PD 1451

**Re: Minor change to PD No. 1451, Subarea A
1043-57 W. Fulton Market**

Re: Minor change for PD No. 1451, Sub area A and B, 1041-43 W. Fulton Market

1 EAST ELEVATION
SCALE: 1" = 40'-0"

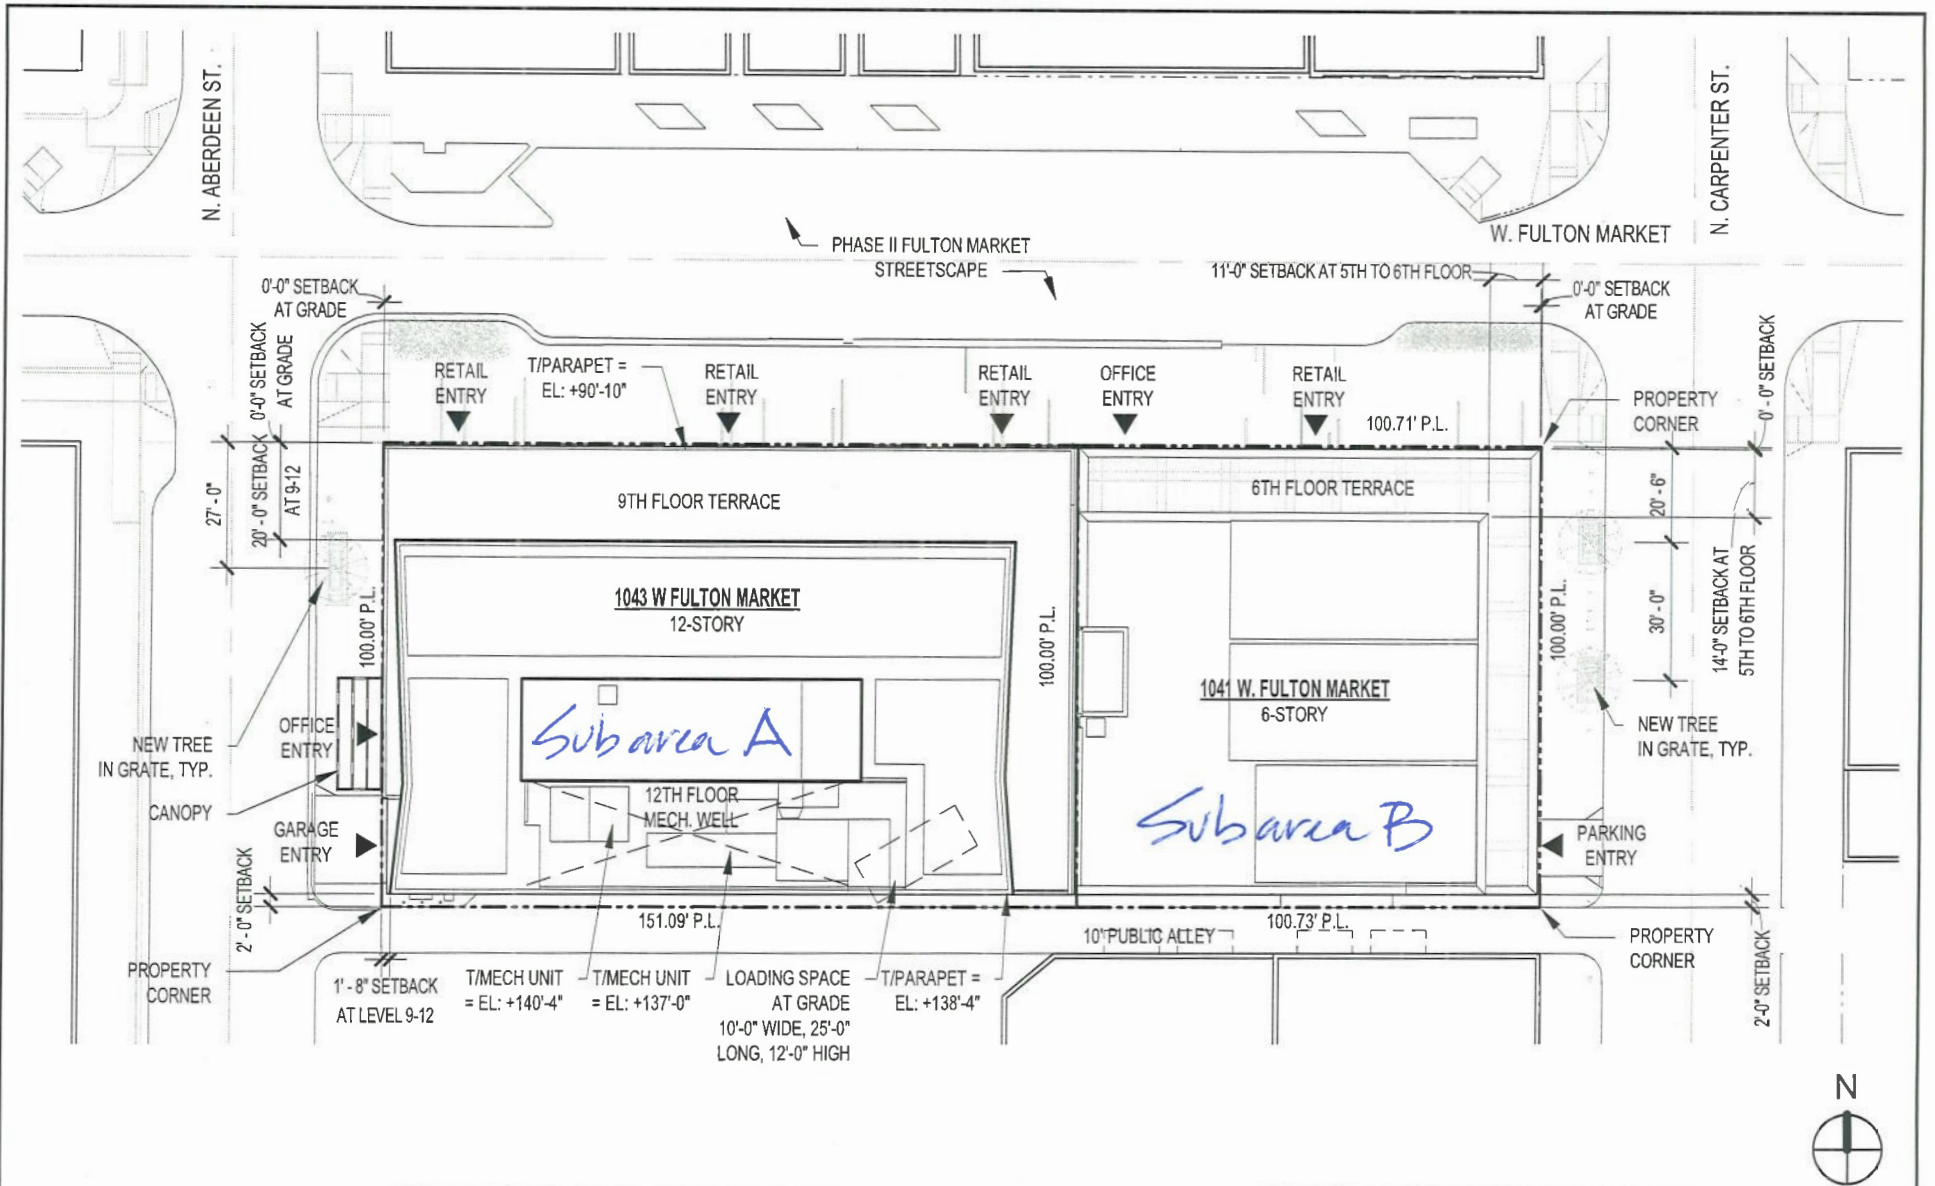
1043-1055 WEST FULTON MARKET STREET OWNER, LLC, the sole property owner of Subarea A, is seeking a minor change to allow windows along an interior lot line on the 8th floor of the east façade of the proposed building in Subarea A located at 1043-57 W. Fulton Market and 225-233 N. Aberdeen Street. The proposed windows match the aesthetic of the windows on the primary facades, and are shown on the attached, revised East Elevation exhibit.

Regarding your request, the Department of Planning and Development has determined that allowing the proposed windows will not create an adverse impact on the Planned Development or surrounding neighborhood, will not result in an increase in the bulk or density, and will not change the character of the development, and therefore, would constitute a minor change.

Accordingly, pursuant to the authority granted by the Chicago Zoning Ordinance and PD 1451, I hereby approve the foregoing minor change, but no other changes to this Planned Development. This minor change is valid for twelve (12) months from the date of this letter unless action to implement the minor change is commenced within such time period and thereafter diligently pursued to completion, including, if applicable, construction consistent with the minor change as authorized by a building permit. If action to implement the minor change, including construction, does not begin within the time set forth, or does not proceed with reasonable diligence, then the approval will lapse and become null and void.

SITE PLAN /
LANDSCAPE PLAN

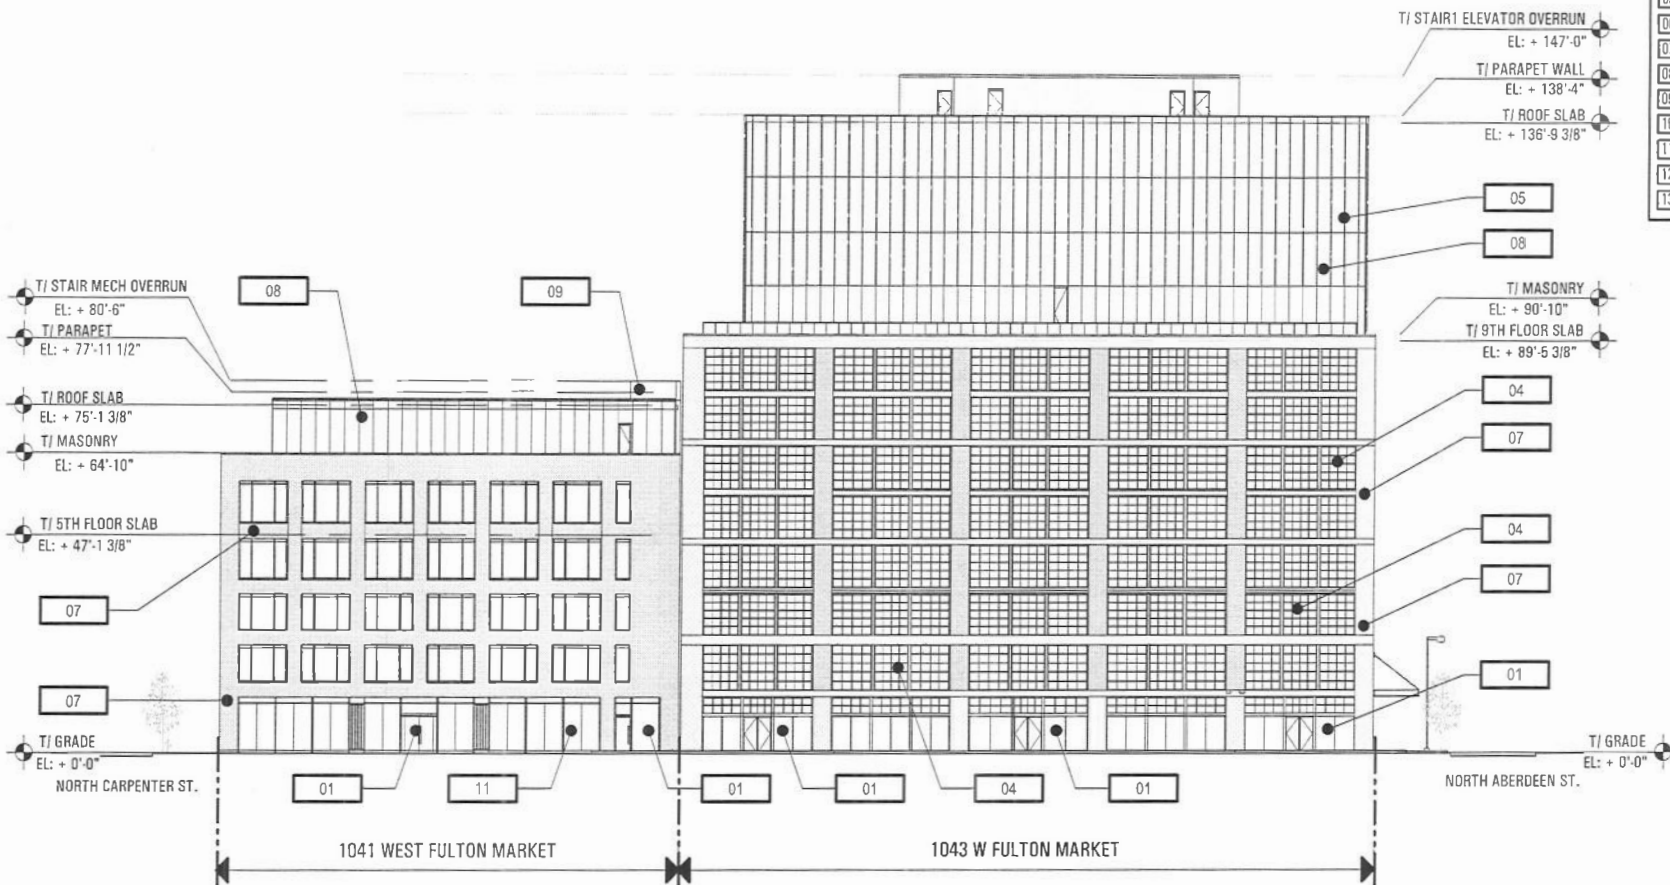
- Change the masonry color and bay spacing on the north and west facades to a red tone that is more typical of the Fulton Market District and increase the bay spacing to reflect the office space use. The hotel use has been eliminated.
- Extend the masonry on the west facade one bay toward the alley.
- Move the main entry from Fulton Market St. to Aberdeen St.
- Relocate the existing Aberdeen curb cut to line up with the new parking garage entrance

constitute a minor change. The Department of Transportation has approved the revised curb cut and site plan. The following revised drawings, dated June 12, 2020, are attached: Site Plan/Landscape Plan, North Elevation, South Elevation, East Elevation, West Elevation, Axonometric Diagrams (6)-1041 Fulton Market-Base, Middle, Top, 1043 W Fulton Market-Base, Middle, Top.
